**MUNICIPAL SERVICES CENTER, COUNCIL CHAMBER
3600 TREMONT ROAD**

BZAP Meeting Date: Wednesday, April 5th, 2023

Subject: Work Session review of revisions to Variance 05-23

Property Owner/Address: Saliaris, 2712 Swansea Road (zoned R-1c)

A
A1-2
NORTHEAST ELEVATION
SCALE: 1/8"=1'-0"

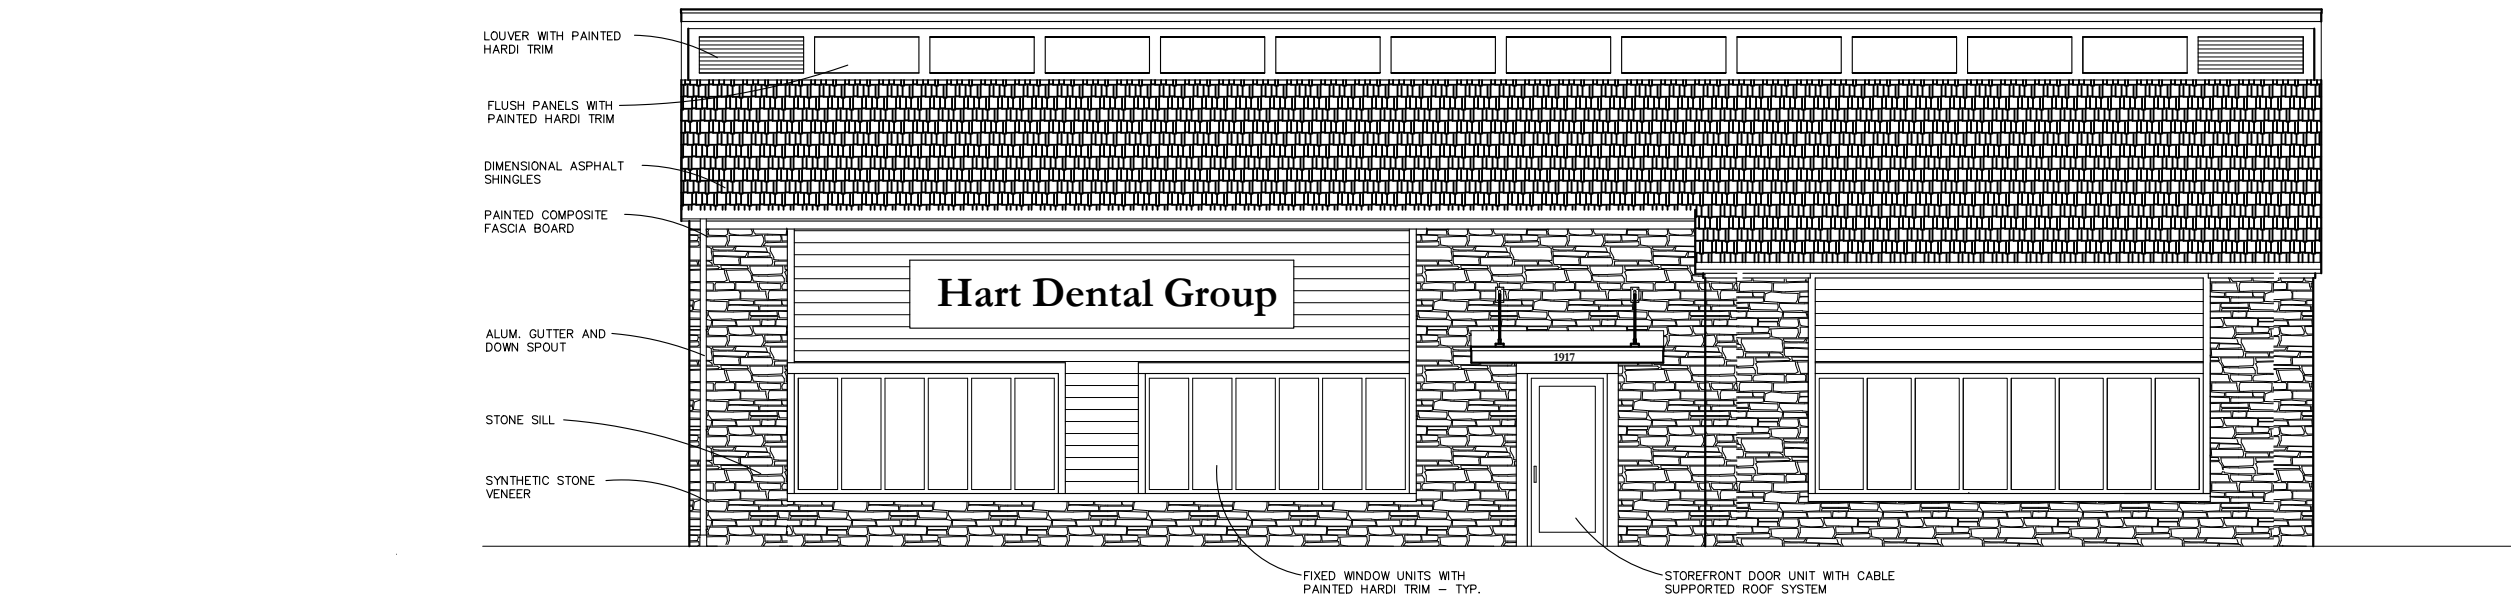
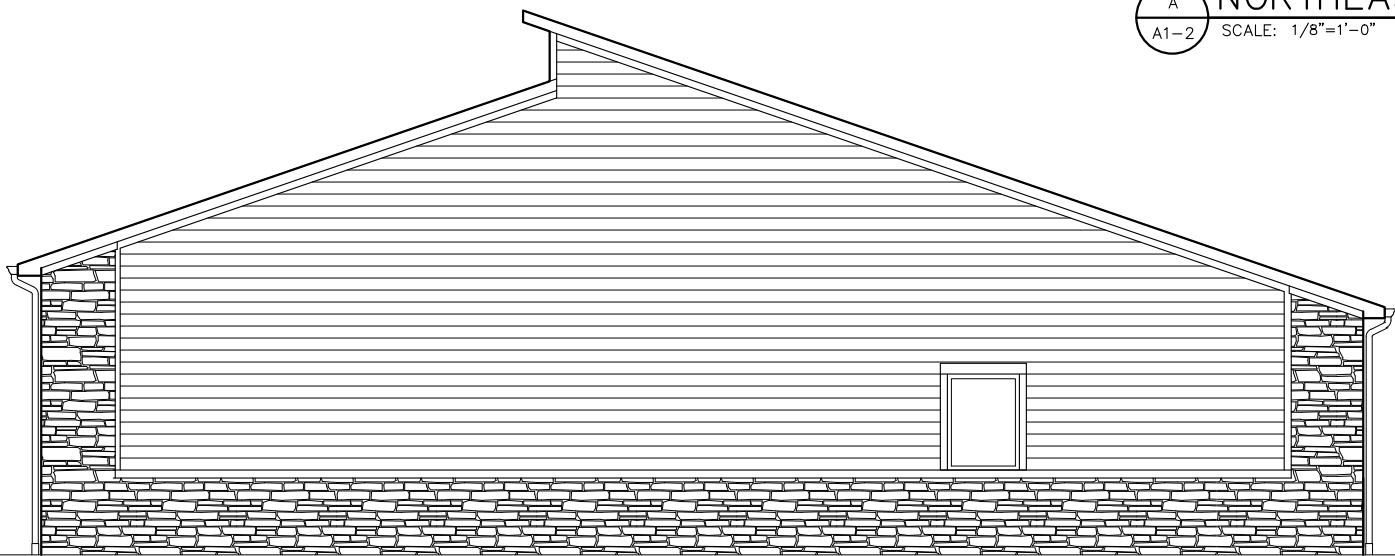
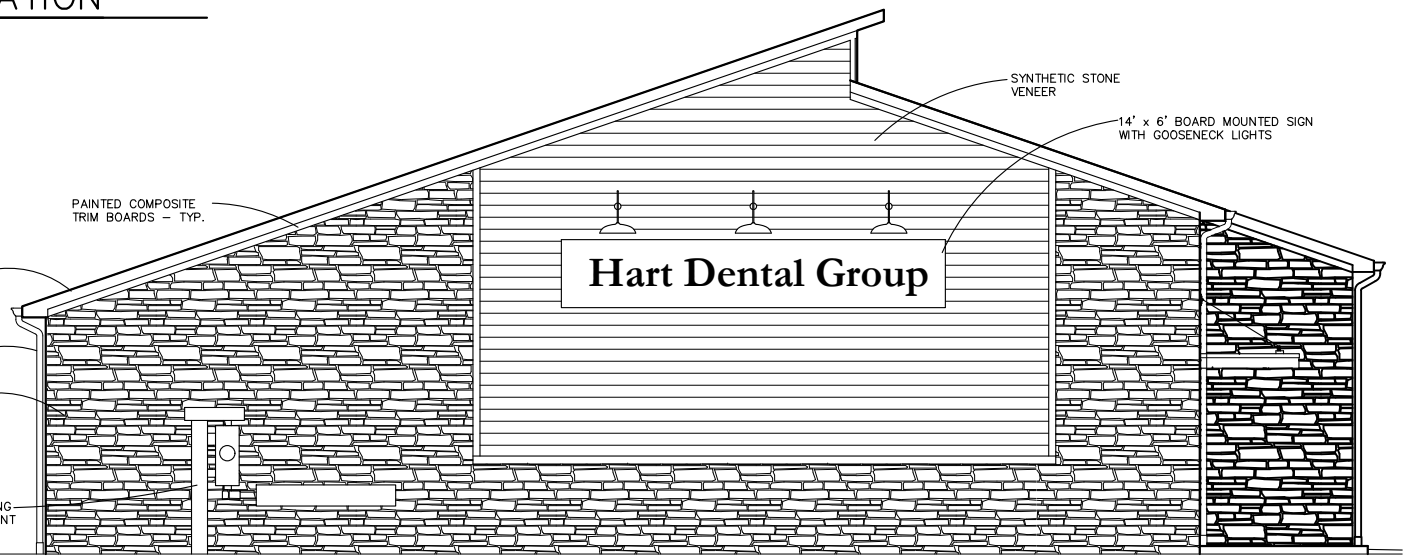
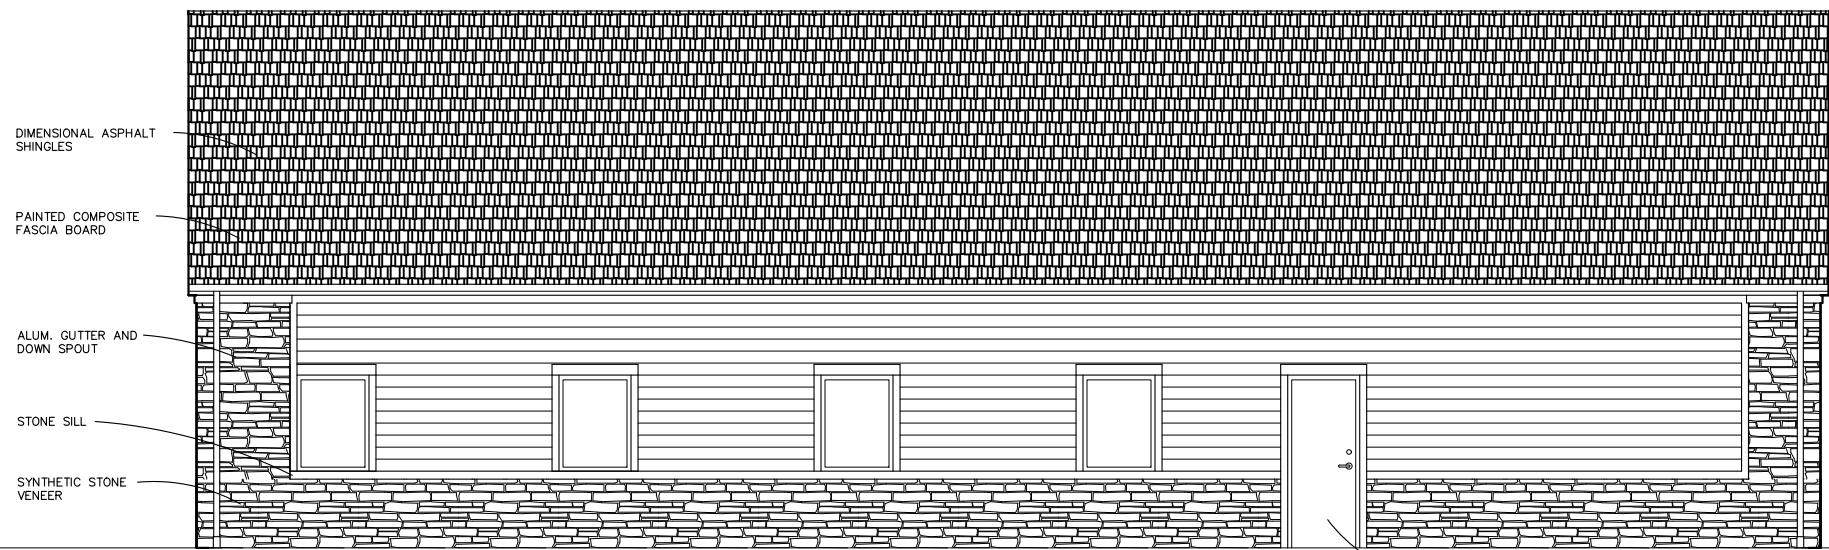
Revised building elevations have been submitted which are a major improvement for this structure and include synthetic stone and painted composite fascia board with dimensional shingles. Two externally illuminated, building-mounted signs are proposed facing each road frontage. A small dumpster enclosure is shown near the southern corner of the building. An old chain-link fence along the southwest property line is being removed and replaced with a six-foot tall privacy fence and landscaping. The Stanford Road driveway is being relocated further from the intersection, and on-site parking for 23 vehicles is now provided.

GARGAE EXPANSION

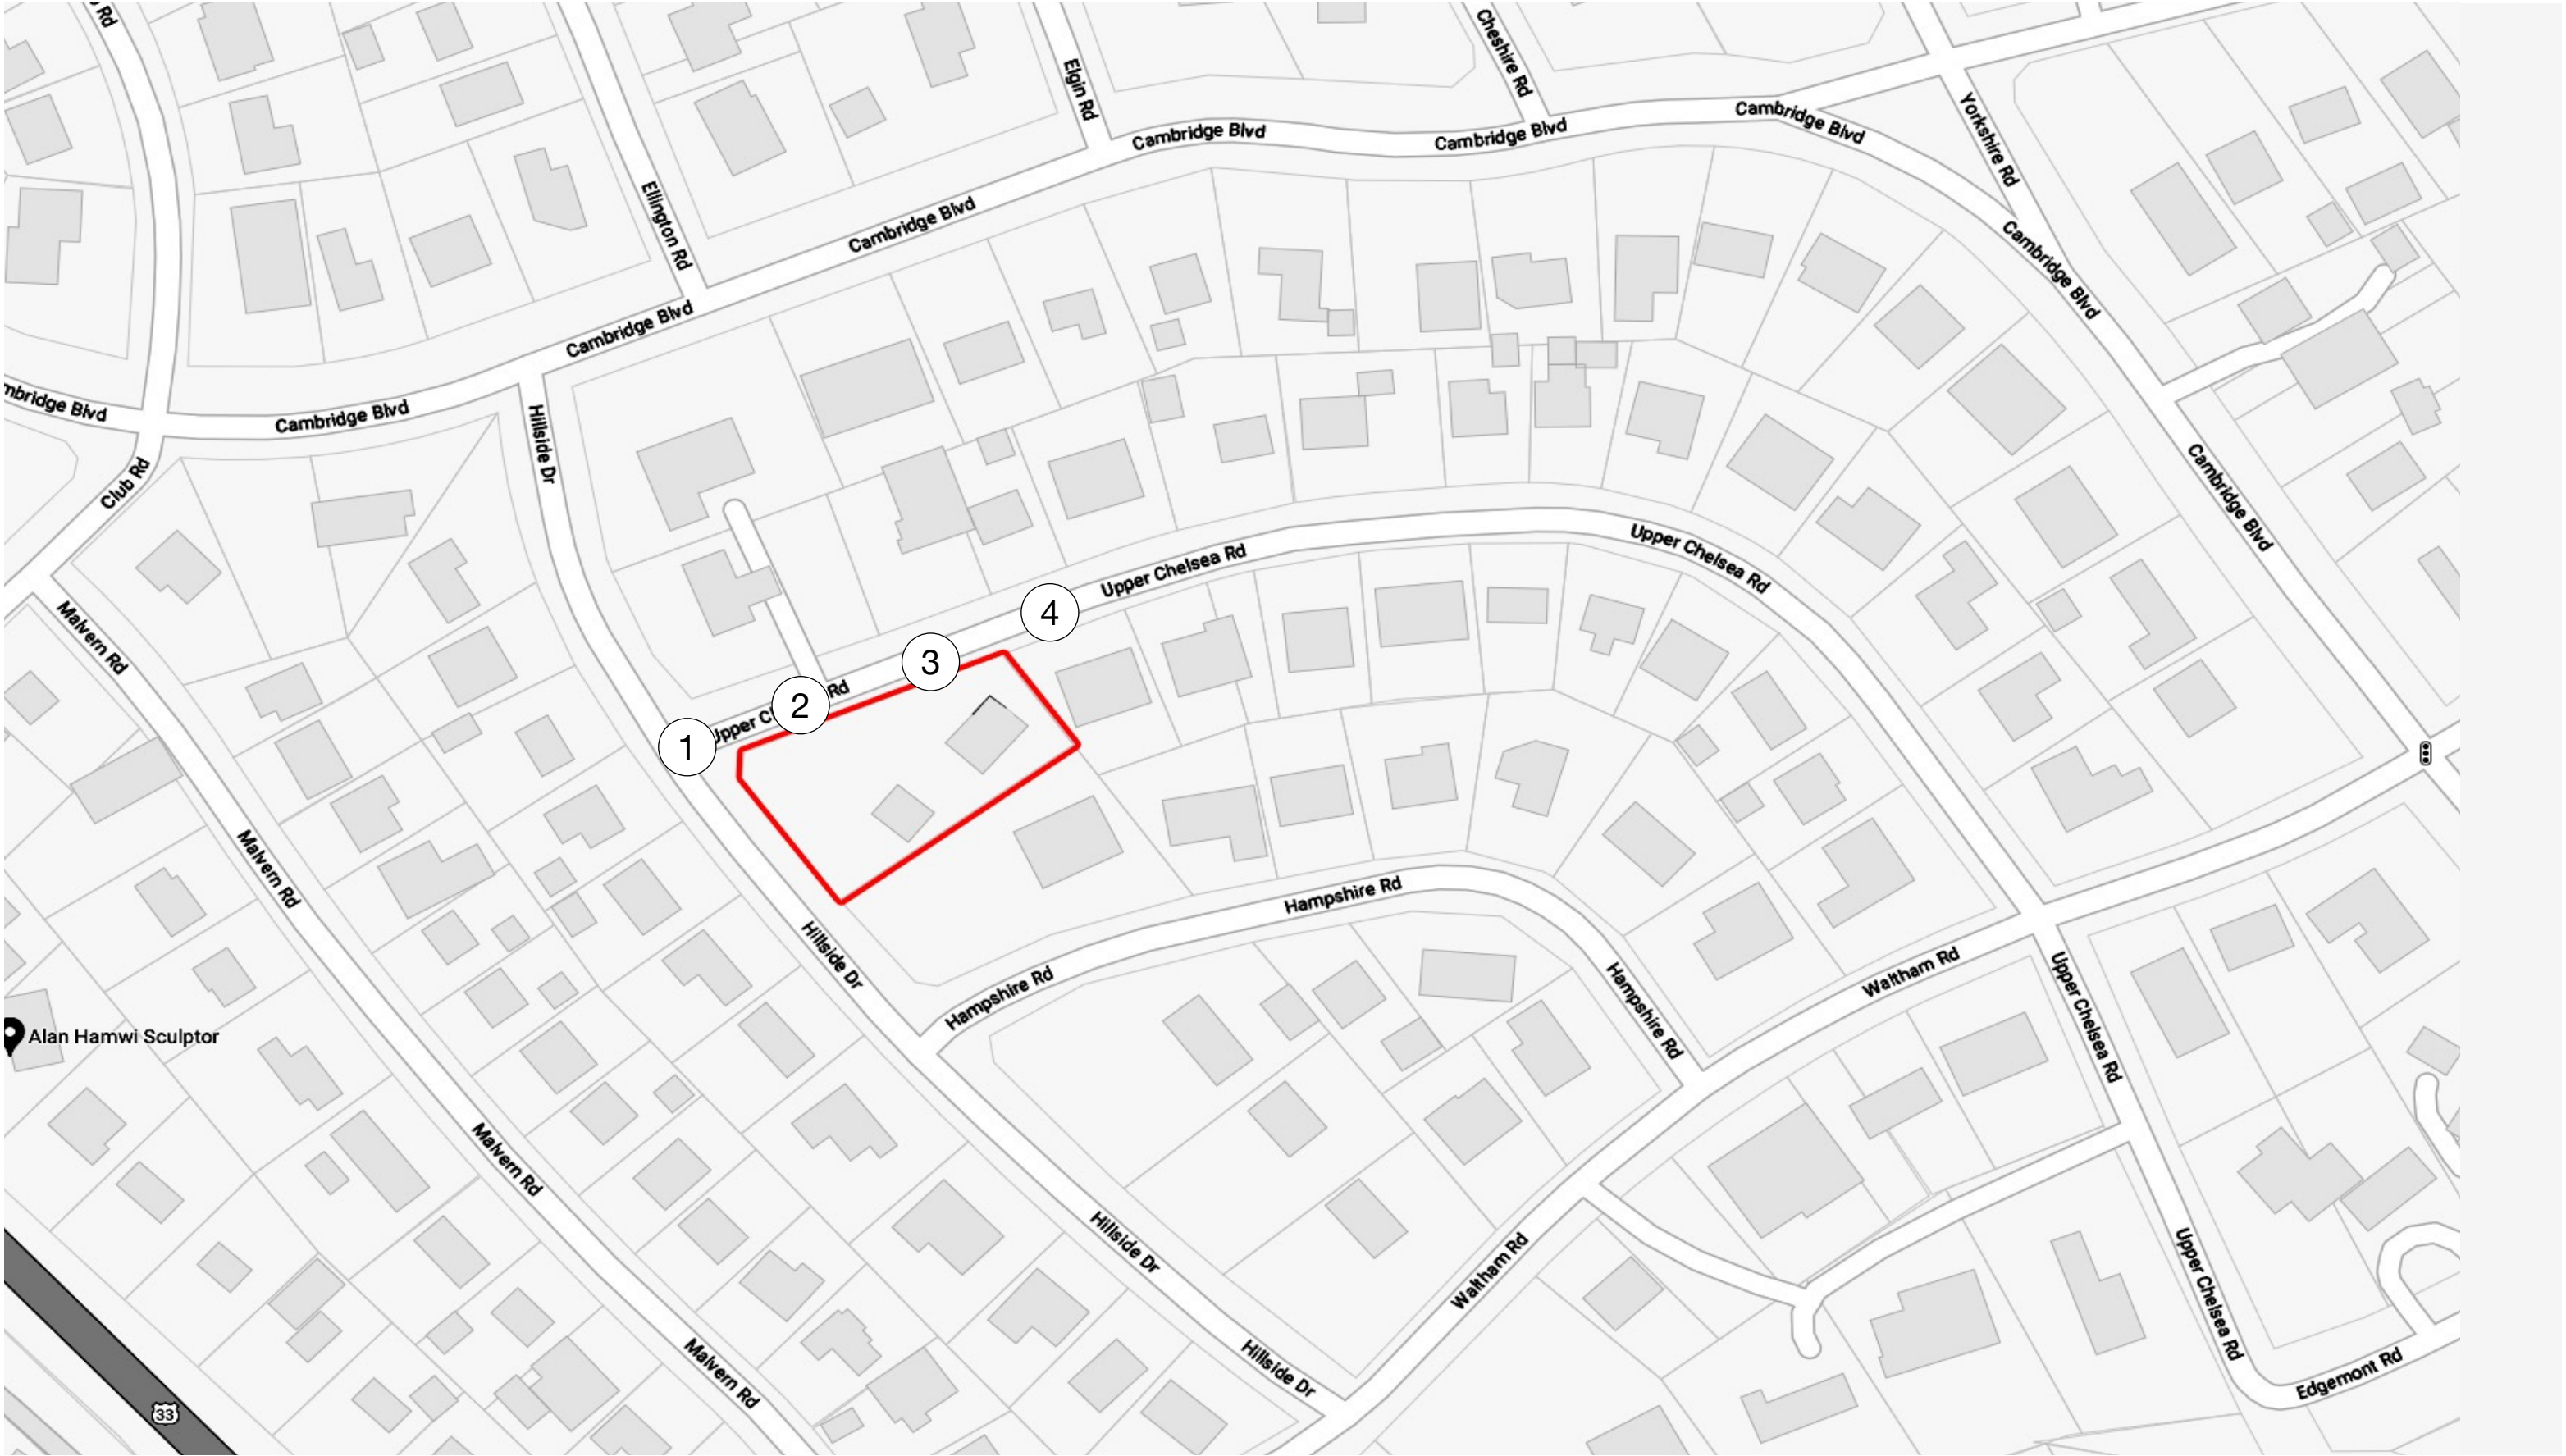
1: What is the viability of the garage addition and what is the potential process for formal review? Other than needing to restructure the existing retaining walls, the current garage (below the second floor) was built in such a way that it cannot accommodate a vehicle larger than a sedan (in height). The goal of the addition would be to construct a functional garage while keeping the overall height to a minimum to take advantage of the grade change and not detrimentally impact the visibility of the existing neighborhood.

Currently the existing garage is below the upper story of the home to the north side of the property. Given the site configuration and topography the garage is built below grade compared to the adjacent property. The driveway access is provided by existing retaining walls. These existing retaining walls show a noticeable lean and will need to be repaired as part of a future project.

The construction of the garage (precast concrete planks over W-Section beams) prevents the client’s vehicles (pickup truck and large SUV) from occupying the current space (bottom of beams 6’-2” clearance). The goal of the addition / expansion would be to provide the code required clearances for a standard garage (depth and clear height) to the north of the property in the area of the current driveway. Understanding that the addition encroaches into the 40’ setback to that side of the property we propose that we create a single-story addition with a low roof to mimic the existing architecture of the house, a majority of which would visibly be below the adjacent grades to preserve the existing sight-lines and character of the neighborhood.

Figure 3 – Aerial view of site with contours.

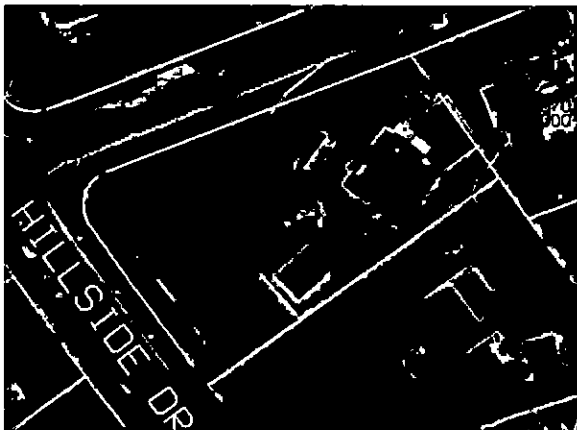
Article 6.09(D)13 of the Unified Development Ordinance prohibits six-foot high fences in front yard setbacks.

The applicants are proposing to install a six-foot high wooden fence along a portion of their south property line. The proposed fence will project 20 feet into the platted 140-foot Hillside Drive front yard setback. Therefore, a variance is necessary.

The City's building history card indicates that the swimming pool, located within the Hillside Drive front yard, was approved in 1965 by BZAP. It appears that the swimming pool was inset into the hillside and is retained by an eight-foot high (+/-) block wall. There are numerous mature white pine trees on the outside edge of the pool that provide screening from the street.
